**Planning Commission
Staff Report**

Subject: Alice Claim aka Alice Lode
Subdivision & Plat Amendment
Project #: PL-08-00371
Author: Christy Alexander, AICP, Planner II

Date: April 8, 2015
Type of Item: Legislative – Subdivision & Plat Amendment

SITE PLAN

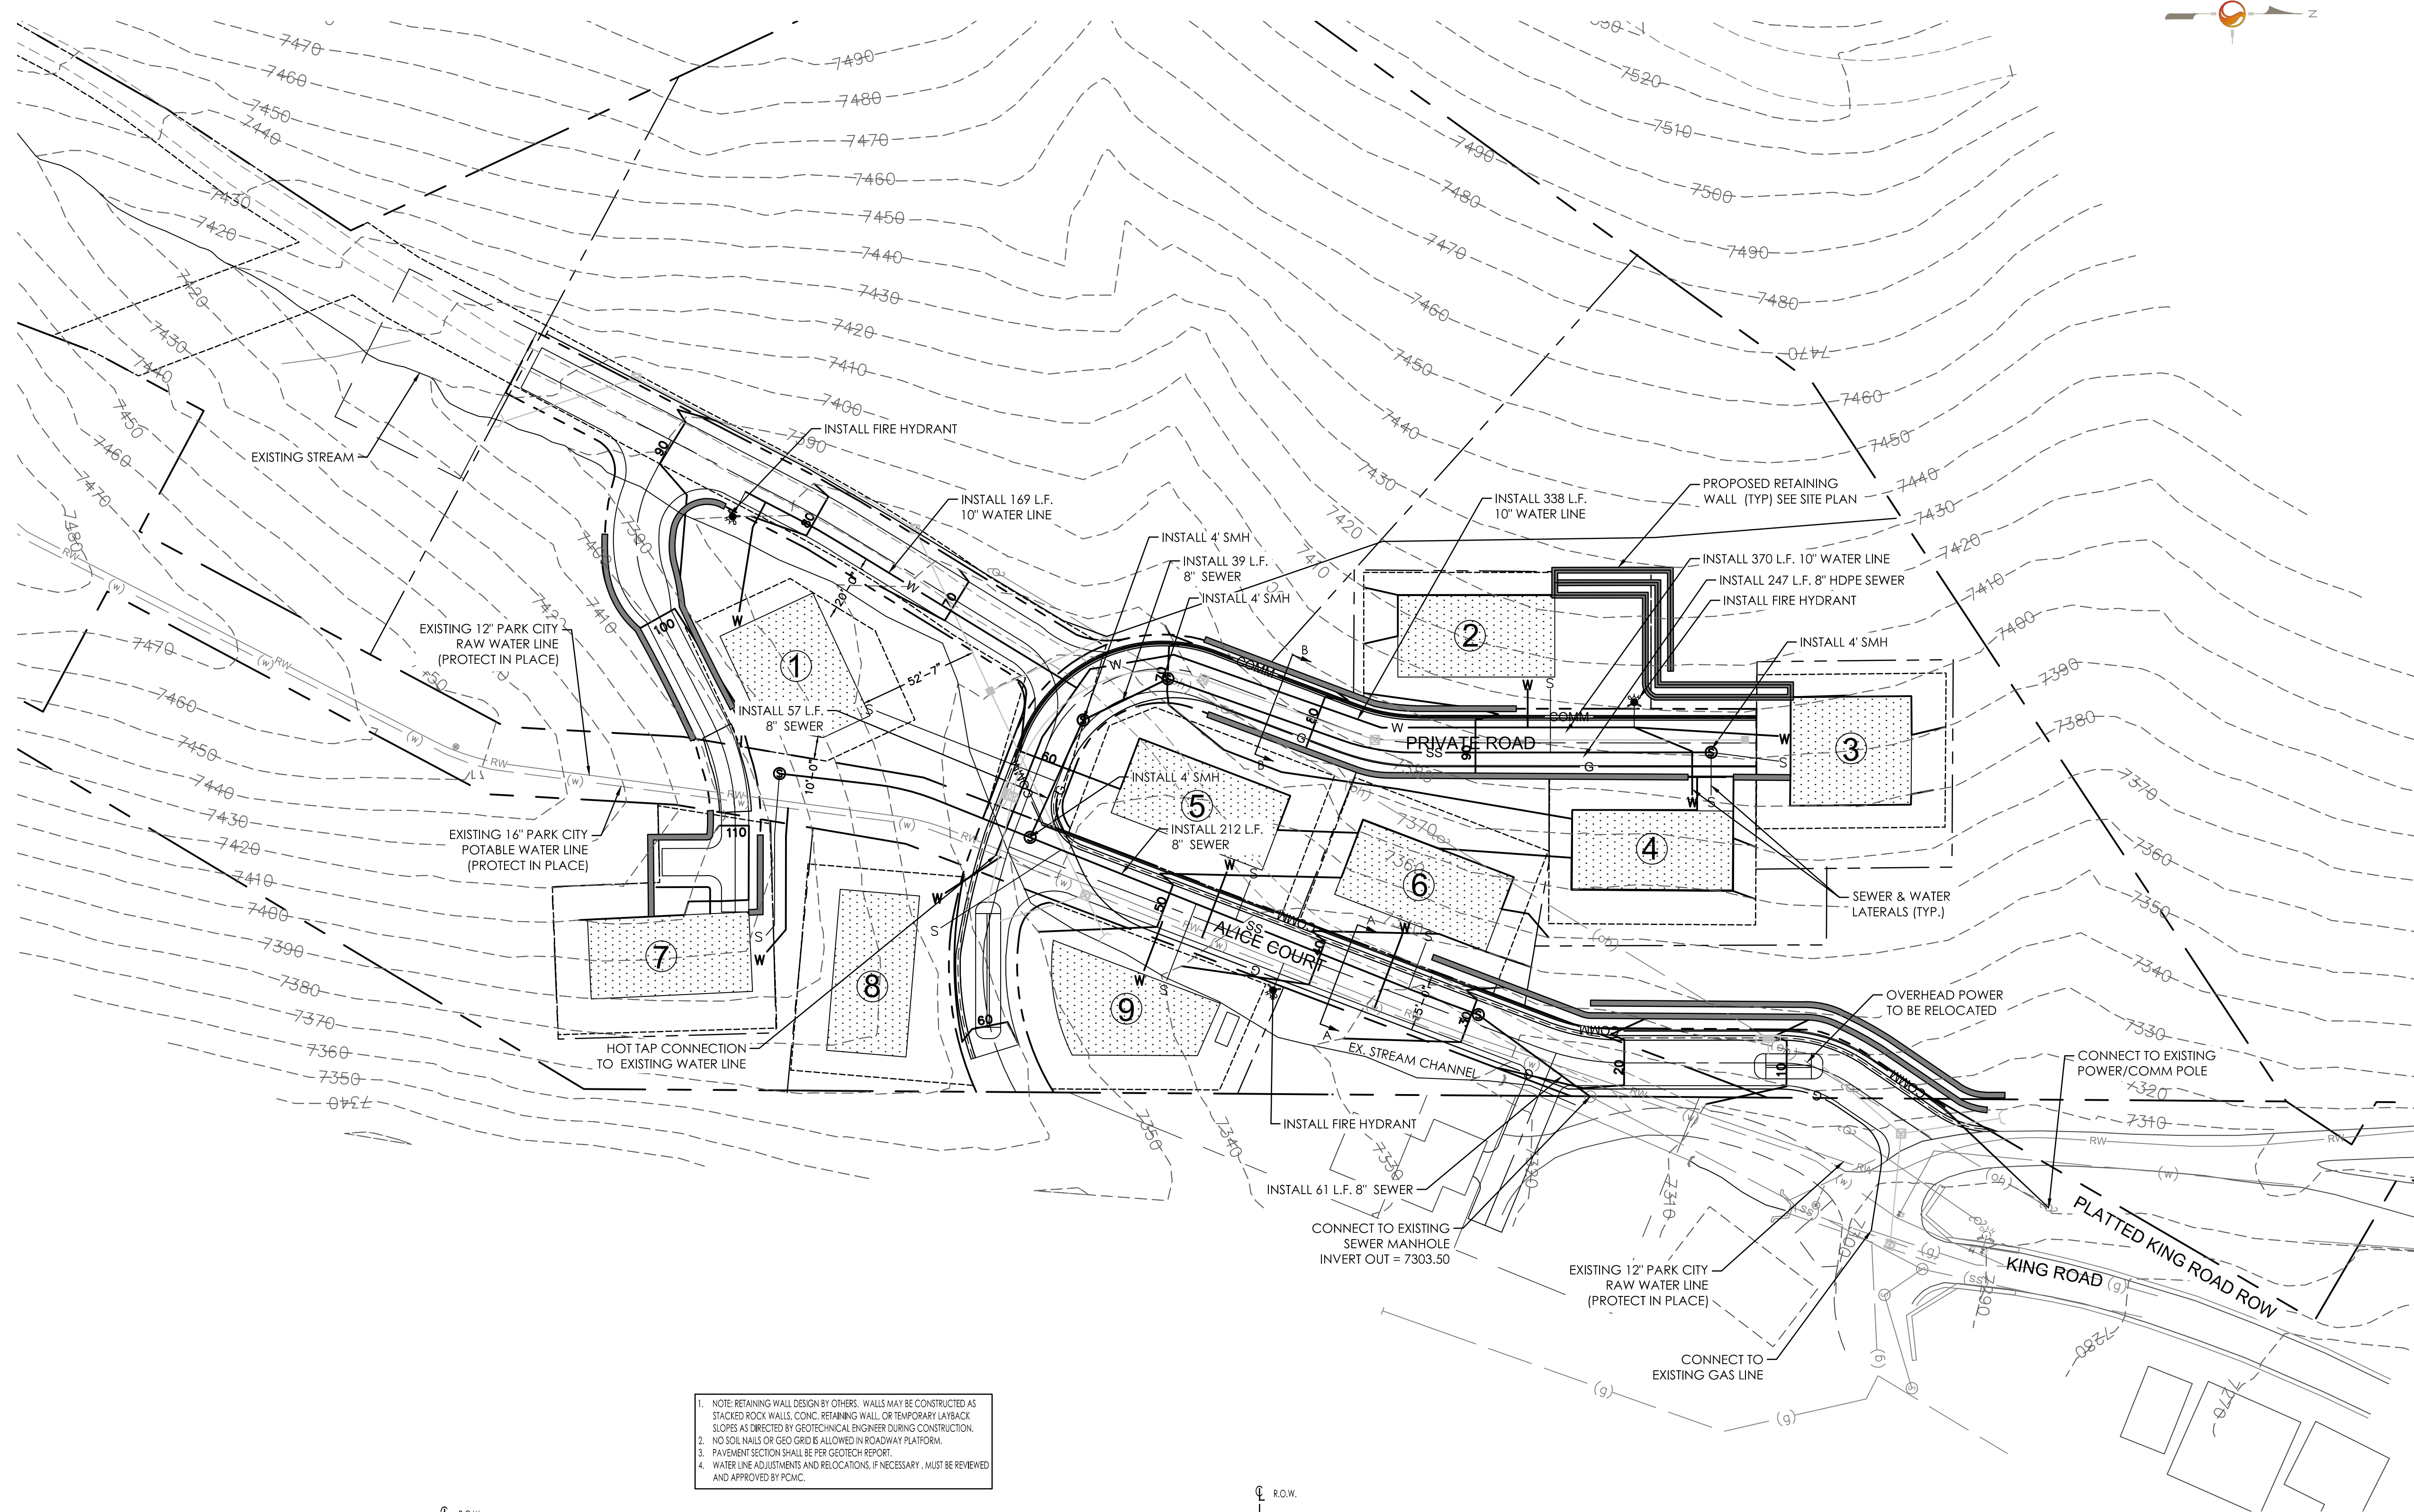
The previously proposed location of the house on Lot 1 was on Steep (15% - 40%) and Very Steep Slopes (greater than 40%). After the October 2014 Planning Commission meeting, the Applicant revised the site plan to bring the home on Lot 1 much further down the hillside, as the Commissioners suggested, and closer to Lots 7 and 8. As proposed Lot 1 is now on a slope of 31% which is only considered Steep and not Very Steep. Within the SLO, 100% of the Very Steep Slopes shall remain as Open Space (LMC 15-2.21-4(I), no vegetation can be disturbed within fifty (50) vertical feet in elevation of Very Steep Slopes, and no Development can occur within fifty (50) feet, map distance, of Very Steep Slopes unless the Planning Commission makes findings as listed in LMC 15-2.21-4(A): All of the Very Steep Slopes found on Lot 1 now as proposed remain as open space, no vegetation is proposed to be

The Applicant took the Planning Commission's recommendation to move the Estate Lot home further down the hillside and has shown that on the proposed plat. With this revision of location **the Applicant is requesting a reduction in the setback requirements for this lot, from the Planning Commission, to a 10' front, 10' side and 20' rear setback from the required 30' front, 30' side and 30' rear setbacks for this District.** As per LMC 15-2.10-3 (C) The Planning Commission may vary required yards in Subdivisions. In no case shall the Planning Commission reduce Side Yards to allow less than ten feet (10') between Structures. The Applicant meets these requirements and proposes approximately 65' between structures. Staff recommends granting these reductions in setbacks so that the home on Lot 1 can be placed further down the hillside as shown on the current proposed site plan thus avoiding the Very Steep Slopes.

The proposed subdivision creates a driveway for lot 1 and lot 7 within the fifty foot (50') setback area from the stream corridor within the Estate zone with Sensitive Lands Overlay. In the January 23, 2015 submittal, the Applicant proposes to culvert the stream underground so as to divert from the 50' setback requirement (see Exhibit ??). The culvert will address this problem as the stream will no longer be above ground within 50' of the home on Lot 1. Any change to the stream will require a Stream Alteration Permit from the State Army Corp of Engineers (regardless if it is navigable water) and may require an amendment to the Voluntary Clean-up Program remediation with the Utah Department of Environmental Quality. The Stream Alteration Permit will be will be required prior to plat recordation. If the Applicant does not obtain the Permit the plat will not be able to be recorded and any approvals shall be null and void. The applicant would then need to submit a new application with a design that meets the 50' setback requirements. Any amendments to the Voluntary Clean-up Program remediation will be required prior to any Building Permit approvals. **These items have been listed as conditions of approval.**

15. The applicant requests a setback reduction from the Planning Commission for Lot 1 to a 10' front, 10' side and 20' rear setback from the required 30' front, 30' side and 30' rear setbacks for this Estate District lot.

Title
CONCEPTUAL UTILITY PLAN

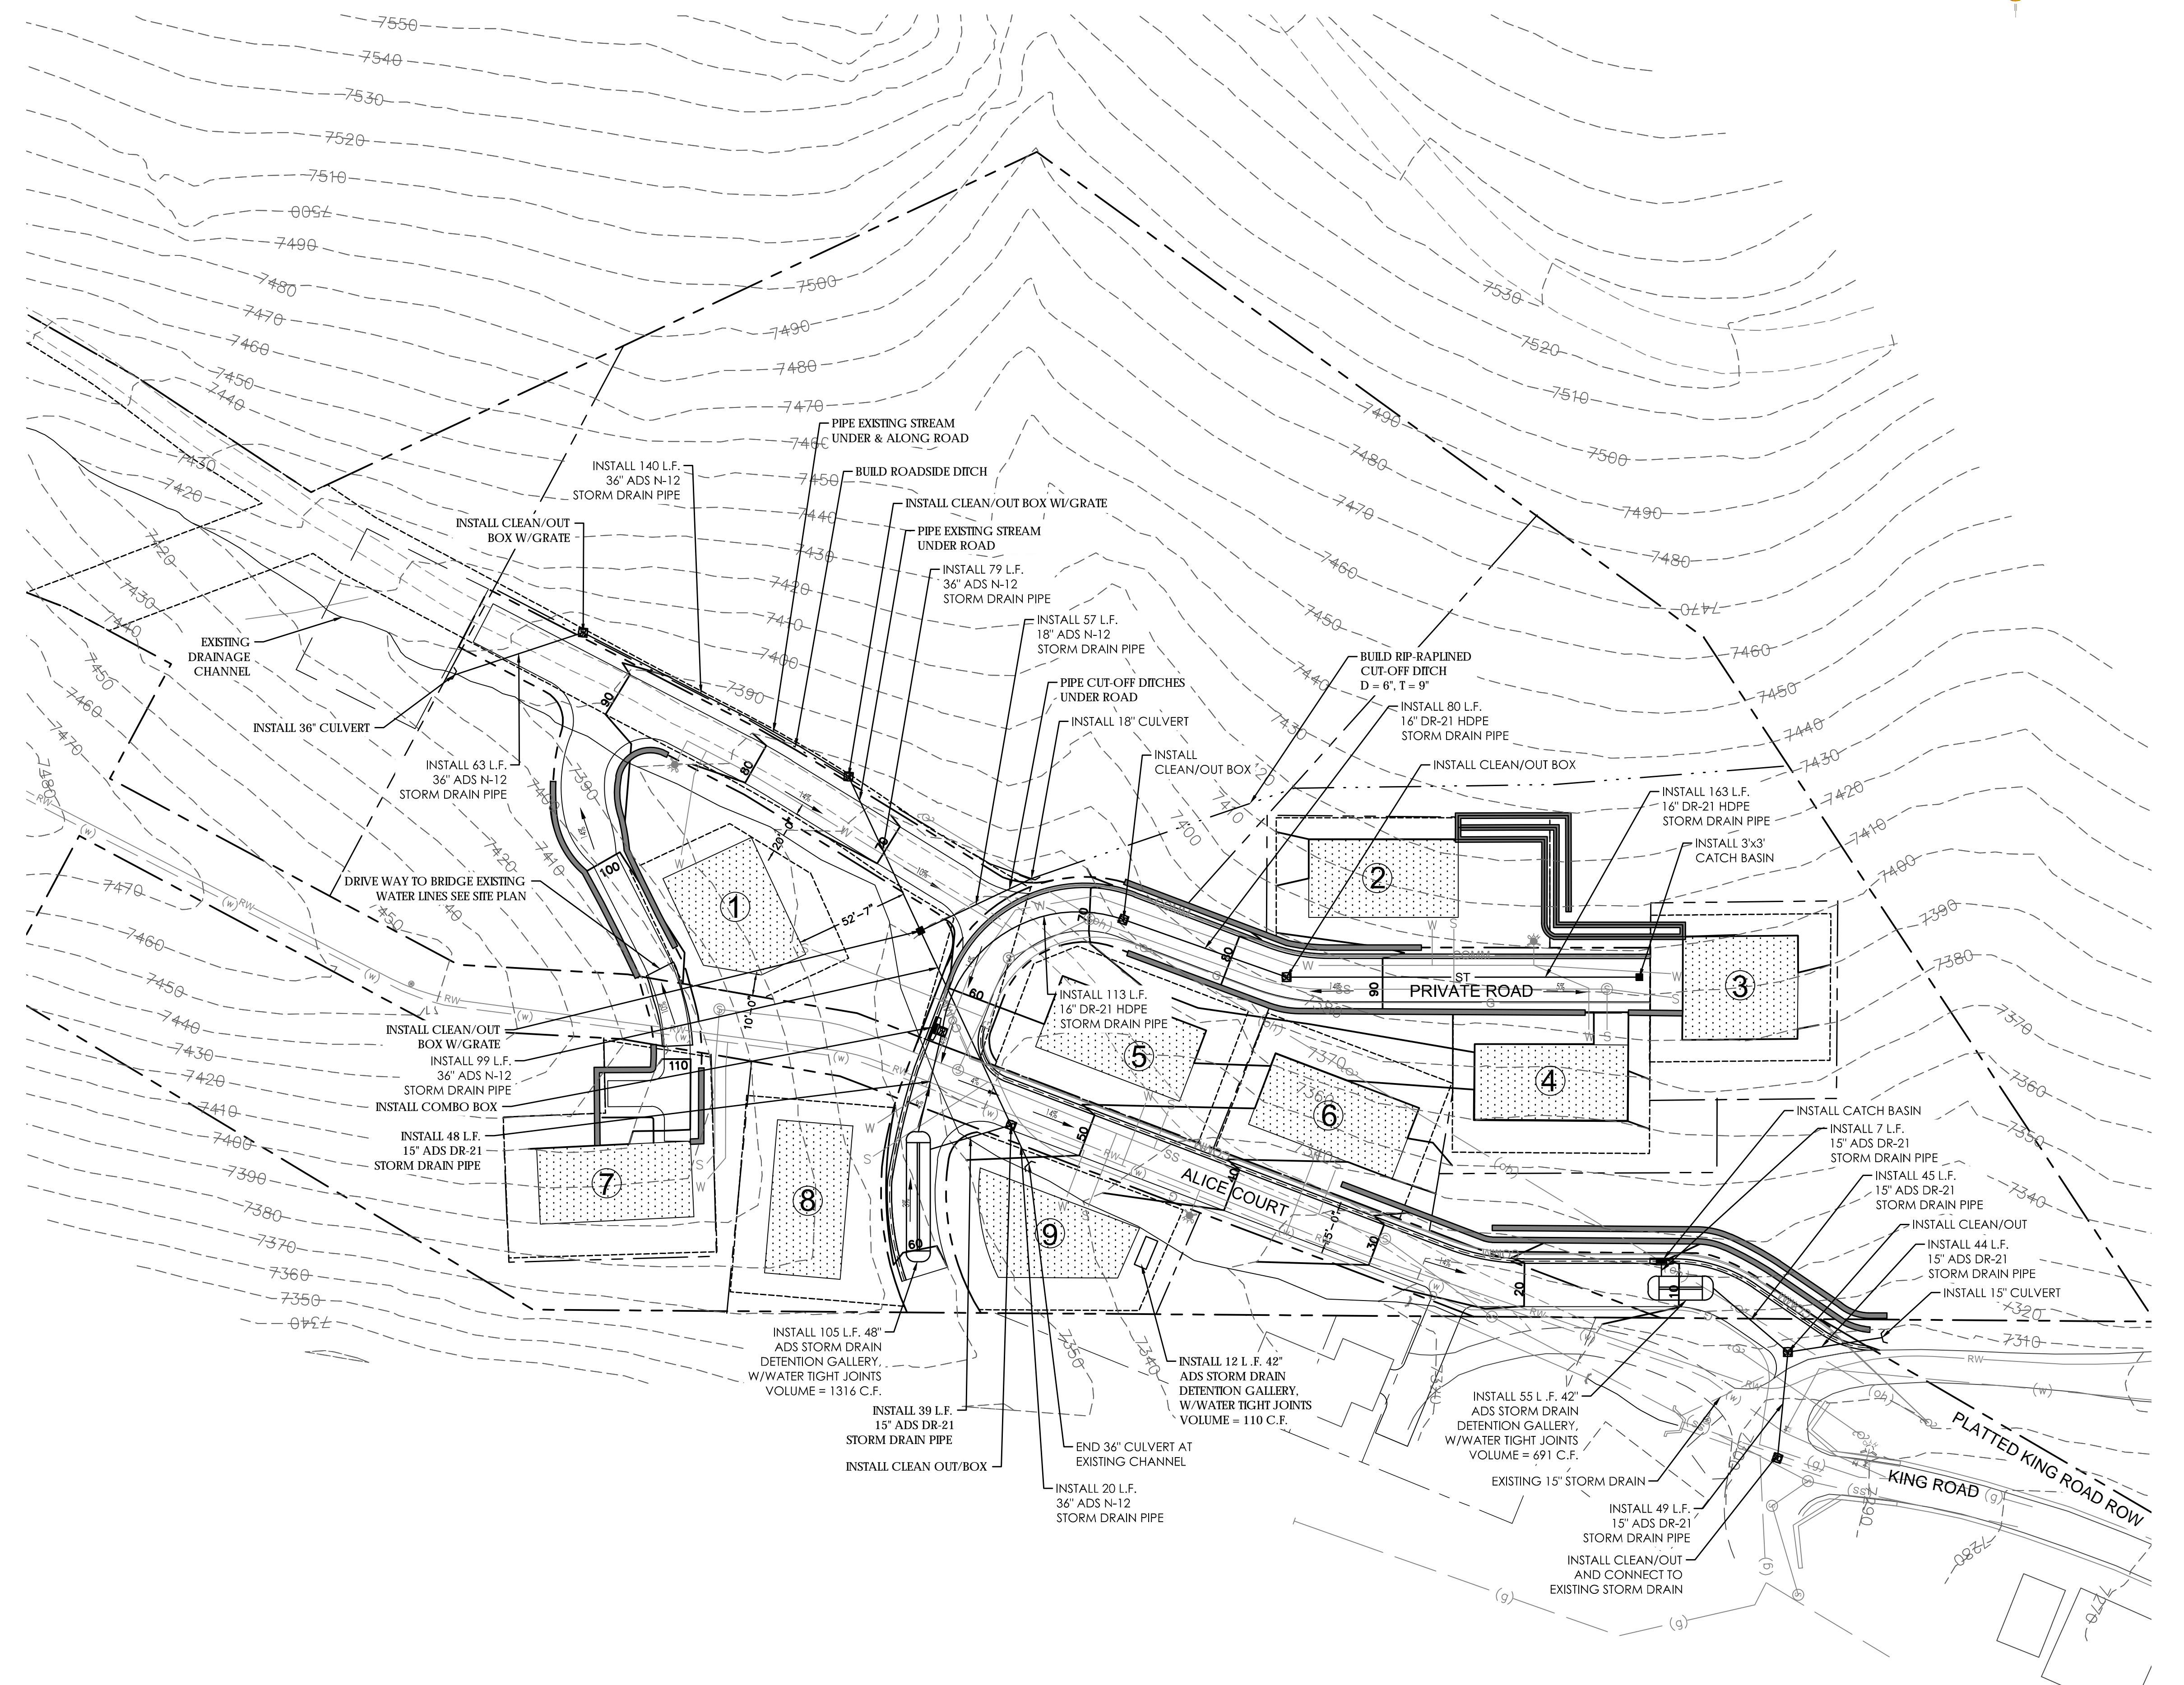
- The road/driveway from King Road to Alice Court to lots 2-3-4 will need to be a minimum of 20-foot clear width as required by the IFC, along with the turn-around / hammer head. The proposed roads meet the required 20 ft. width. **The utility plan will need to be revised to show how each of the main and dry utilities**

- The Applicant has revised the utility plan to show cross sections of how they will grade the private drive to Lot 7. Retaining walls cannot be built over utility lines and as presented the site plan appears that the private drive will need retaining walls greater than 6'. The Applicant has thus proposed a bridge over the City's property to Lot 7. **The proposed drive and bridge shall be engineered to meet City Standards prior to plat recordation and has been listed as a condition of approval.** Any retaining wall over 6 feet in height along this private drive will need a Conditional Use Permit approved by the Planning Commission. The applicant has included the retaining walls along the private drive as part of their concurrent CUP.

17. The maximum total floor area of all homes within this subdivision shall be limited to 5,000 sf including basement and garages.
 18. The utility plan will need to be revised to show how each of the main and dry utilities will be able to be placed within the drives with required separations and approved by the City Engineer prior to plat recordation.
